Technical Review of Goldfield Ranch Water Reclamation Facility Small Plant Approval Request

Guy Carpenter, P.E.

Provide third party technical review of the Small Plant Review and Approval request to the Maricopa Association of Governments (MAG) for The Preserve at Goldfield Ranch proposed water reclamation facility (WRF)

Verde River Designated Uses in This Reach

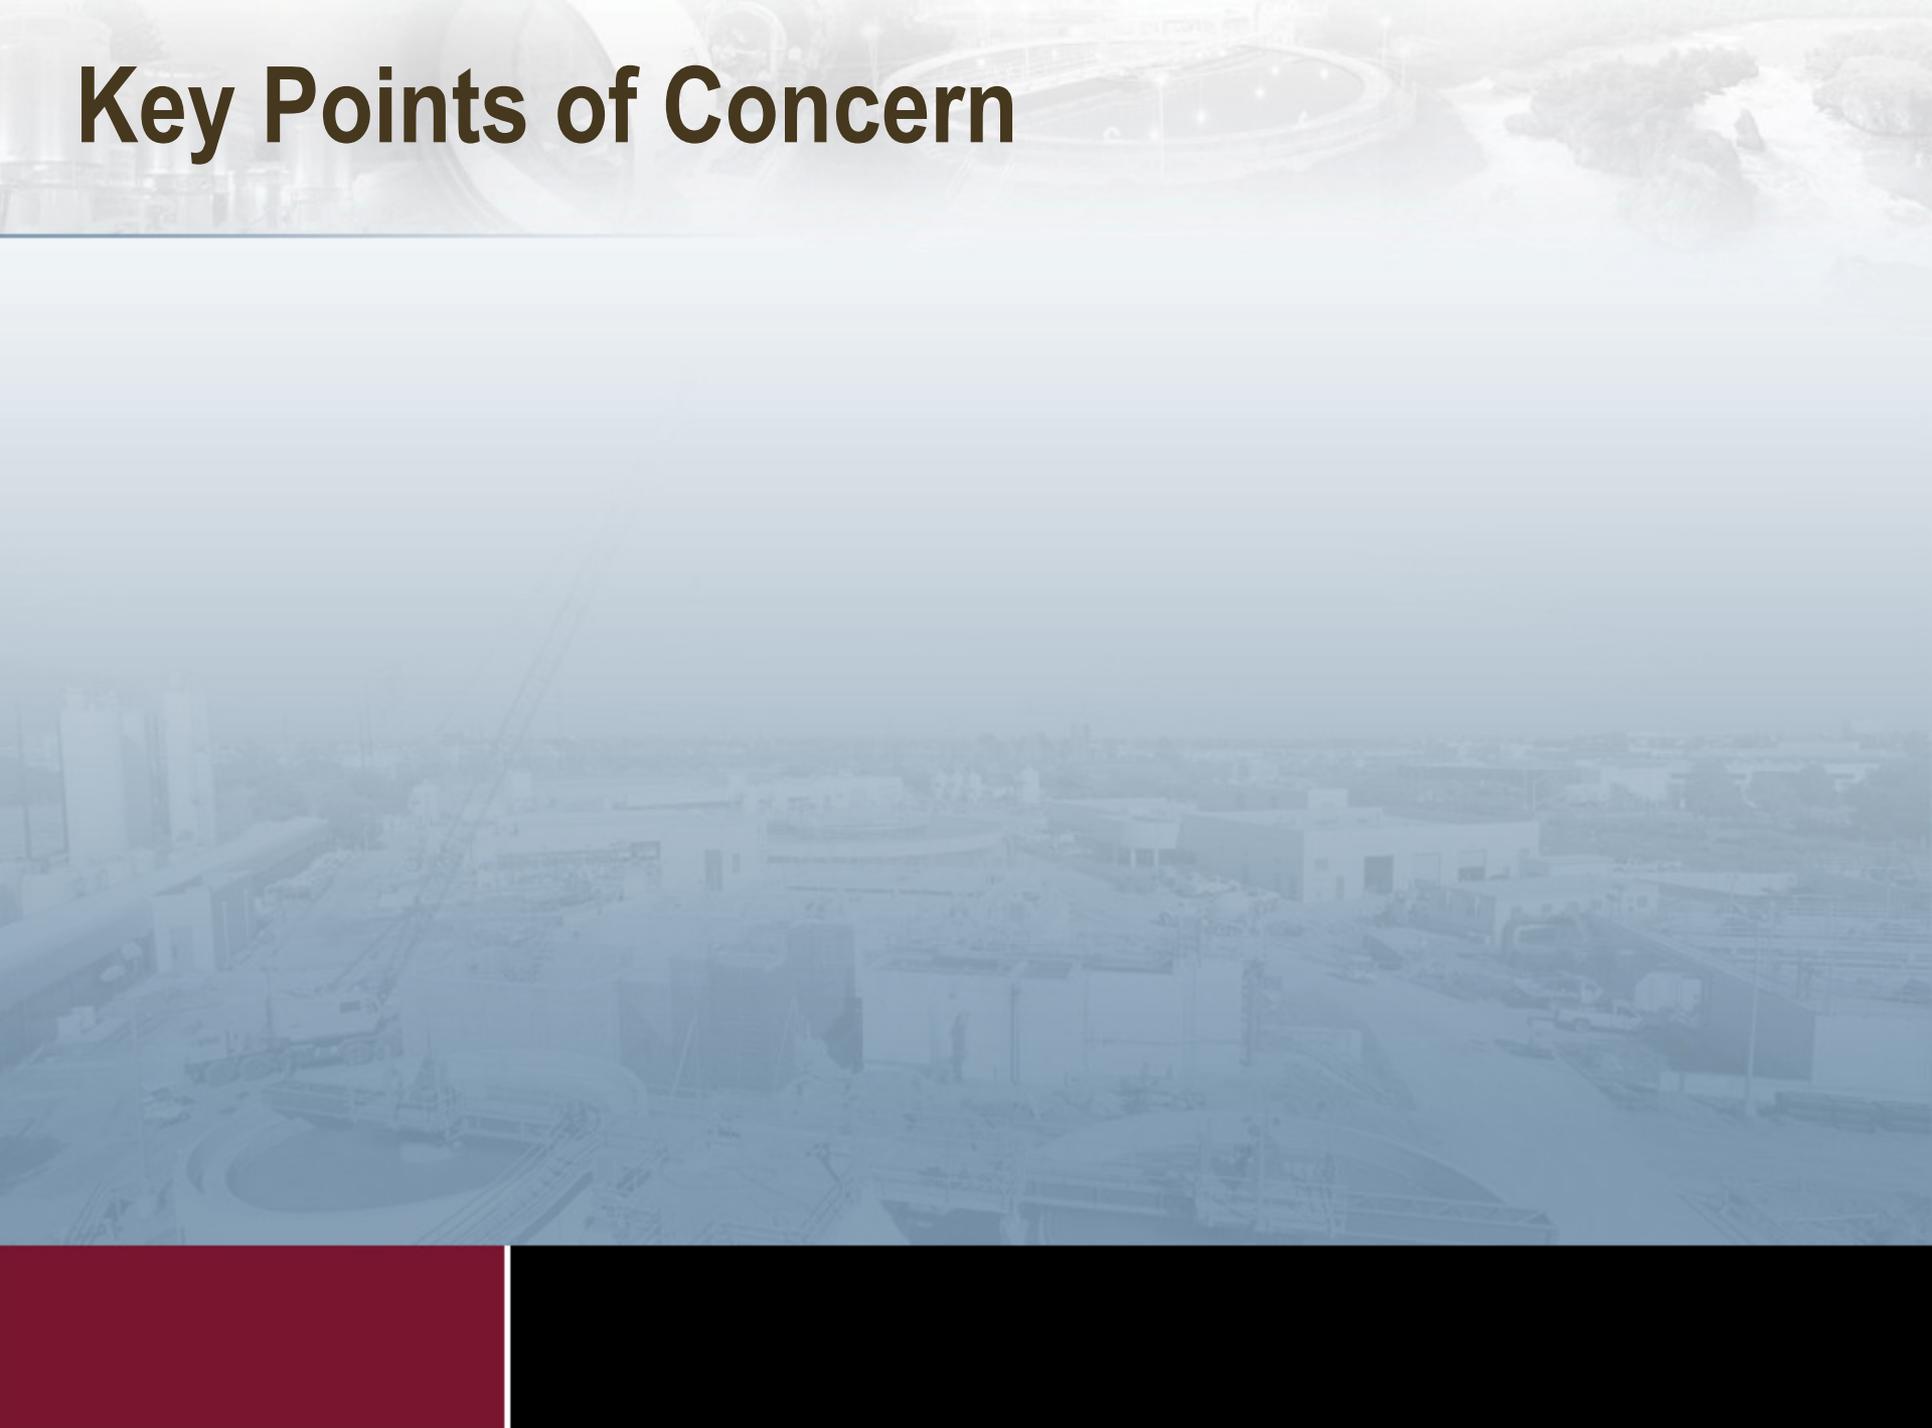
- Aquatic and Wildlife, Warm Water
- Full Body Contact
- Domestic Water Source
- Fish Consumption
- Agricultural Irrigation
- Agricultural Watering
